# CITY PLANNING COMMISSION

- APPLICATION:
1. Negative Declaration
  2. Special Permit to develop two office/warehouse structures on 4 vacant acres in M-1(S)(PUD) and (HC-PUD) in Norwood Tech Business Park
  3. Lot Line Adjustment to create 4 acre parcel to allow two office/warehouse structures totaling approx. 60,000 square feet

APPLIC. NO. P84-1:1

**NORWOOD TECH. BUSINESS PARK**  
 Sacramento, California  
 Norwood Ave. & Hwy 80  
 For: Mr. John Banchemo

**SITE PLAN**

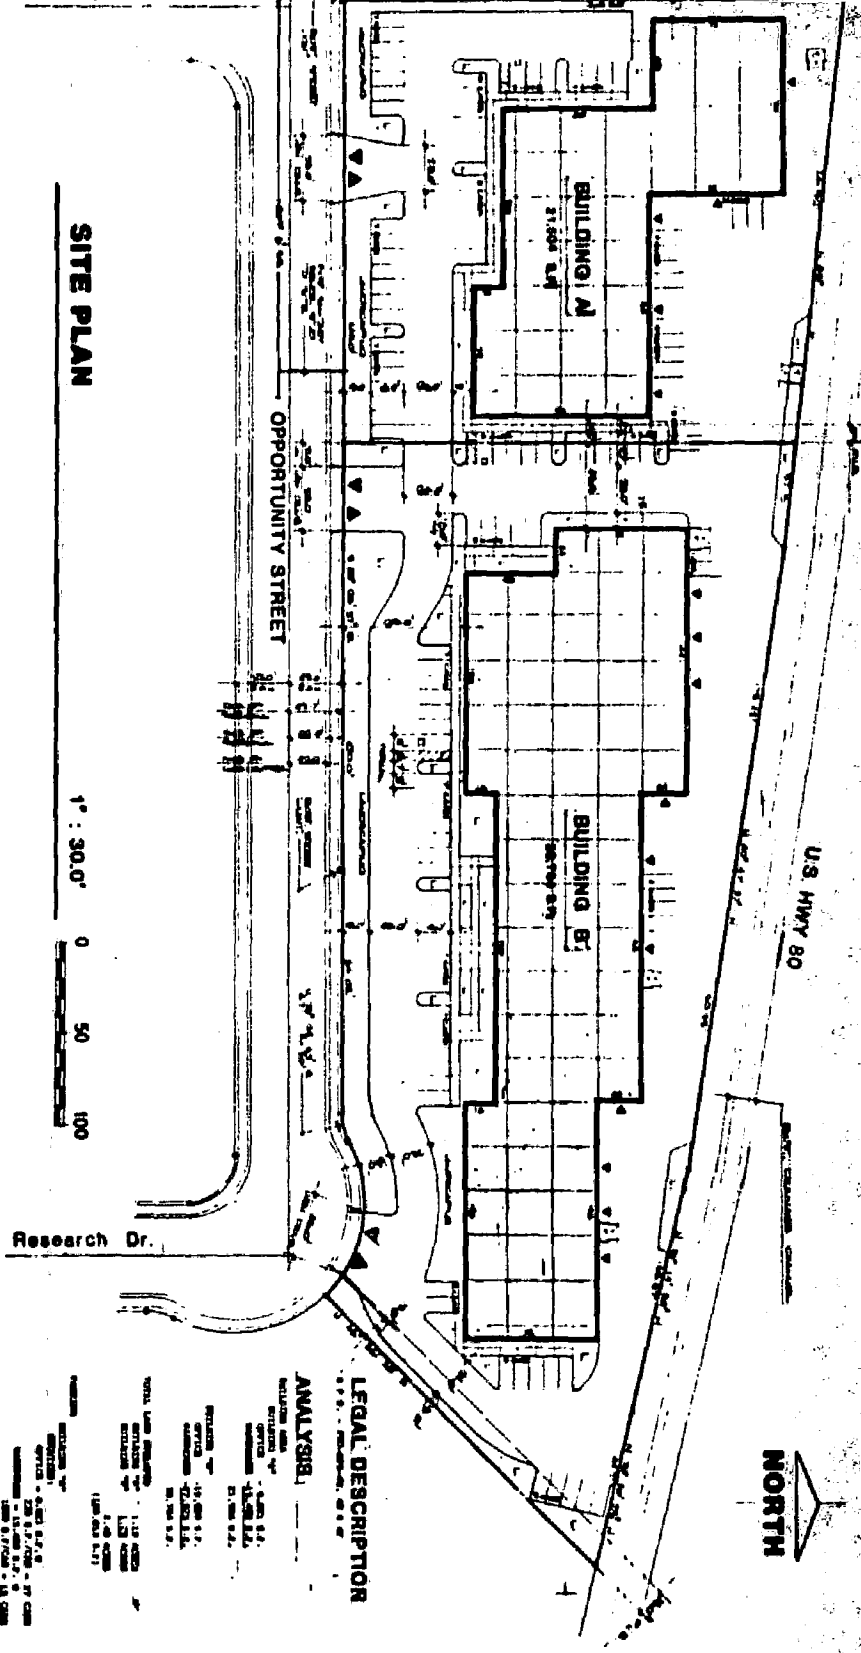
Traffic: Less paving would be required if the auto parking at Building B used separate driveway entrances (540 sq. ft. vs 3,000 sq. ft.) The western-most driveway need be only 25' - 30' wide if it serves only automobiles.

Electrical: The western edge of the proposed driveway at Development Drive should be moved easterly by at least five feet so it will not be in conflict with the existing street light.

4. Access to the rear of Building A is via the adjacent parcel. The parking spaces at the east end of Building A straddle the property line. These spaces should be located on either one or the other parcel. The required parking for each building should be provided as nearly as possible entirely on their respective parcels. A reciprocal parking and access agreement should be provided for review and approval prior to issuance of building permits.

6. The two-foot overhang area of the parking spaces should be incorporated into the adjacent landscape, or walkway improvement, in accordance with the PUD Guidelines (except for handicape spaces).

7. A minimum 50-foot setback from the freeway and drainage canal is required for Lots 8 and 9. Both Buildings A and B as shown are 20 feet at their closest point. A redesign of the building is necessary to meet the required setbacks.

8. The freeway side of both buildings has an architectural treatment different from the front elevations. The contrast is most apparent at those corners of the building where the brick ends and the concrete tiltup begins. The loading areas at the rear of the buildings will be typical of other warehouse buildings in non-PUD areas in the City.

The project, as designed, does not meet the objective of the PUD, "to preserve and enhance the aesthetic values throughout the project." Furthermore, the guidelines require that finished building materials shall be applied to all sides of the building which are visible to the general public, and occupants of the same and other buildings. Again, a redesign is necessary to comply with these guidelines.

9. Although trash enclosures are shown on the site plan, no details are provided on the floor plans and elevations. Plans that comply with PUD guidelines shall be provided for review and approval prior to issuance of building permits.
10. A sign program has not been submitted with this application. Any signs for the project shall conform to the PUD guidelines and the City Sign Ordinance, and must be submitted for review and approval prior to issuance of sign permits.

- a. The applicant shall redesign the project with the following and be reviewed and approved by the Planning Director prior to building permit issuance:

- 1) locate parking spaces for Building A on either one parcel or the other. The required parking for each building shall be provided as nearly as possible entirely on their respective parcels;

- 3) provides minimum 25-foot landscaped setback along the front property line;
  - 4) the two-foot overhang area of the parking spaces shall be incorporated into the adjacent landscape or walkway improvement;

- 5) a minimum 50-foot setback shall be provided for both buildings, from the freeway and drainage canal boundary;
  - 6) the buildings shall comply with the adopted PUD guidelines and provide finished building materials applied to all sides of the buildings;

- 7) location and design of trash enclosure structures;
  - 8) the western edge of the proposed driveway at Development Drive shall be moved easterly so it will not be in conflict with the existing street light.

### PRELIMINARY LANDSCAPE PLAN

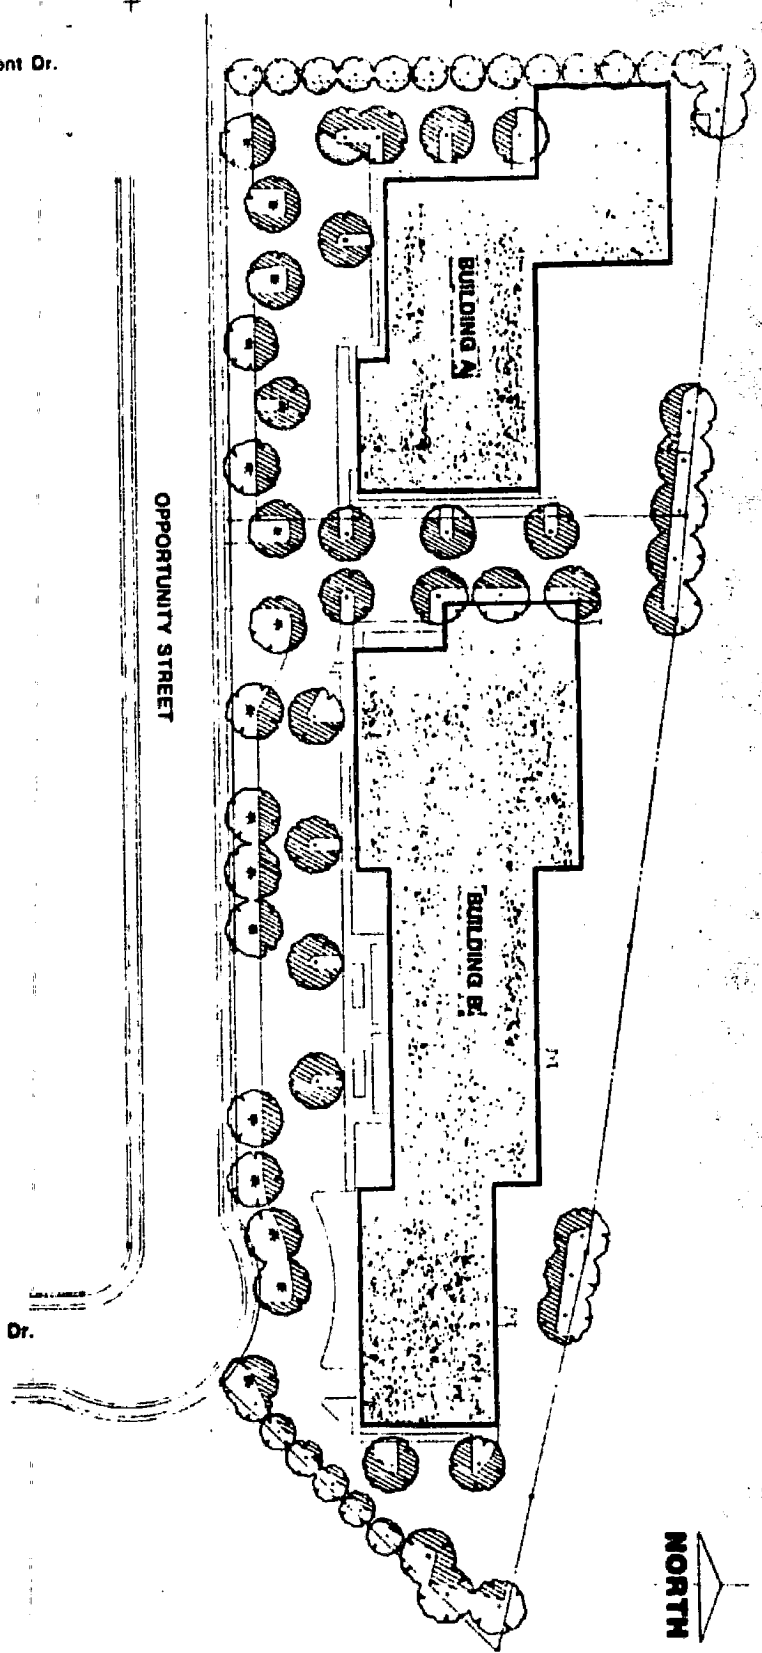
5. There is virtually no landscaping at the rear of the buildings. The approved schematic plan indicates a continuous on-site landscaped strip along the freeway. Only about one-third of the freeway footage is now proposed for landscaping. Landscaping in the front setback is inadequate. The PUD Guidelines and schematic plan provide for a minimum landscape setback of 25 feet. Only 15 feet is proposed. Revised plans should be provided for review and approval prior to building permit approval.

2. Landscape Setback Reduction: The Norwood Tech PUD Development Guidelines also require that all properties fronting on a public street provide for a 25-foot landscape setback. The applicant is proposing a 15-foot landscape setback (see Exhibit D). The purpose of the 25-foot landscape setback is to provide for a park-like atmosphere. This 25-foot landscape setback is a standard requirement for M-1(S) and M-2(S) (Industrial Park) zones throughout the City. The approval of the reduced landscape strip would set a precedent for other properties in the PUD area. The other four projects which have been approved in this PUD area by the Commission have complied with the 25-foot landscaped setback. Staff therefore cannot support the reduced setback.

- 2) submit a revised landscape plan that provides continuous on-site landscaping strip at least four feet wide along the north property line adjacent to the freeway and drainage canal; and

- b. submit a revised landscape plan that provides continuous on-site landscaping strip at least four feet wide along the north property line adjacent to the freeway and drainage canal;
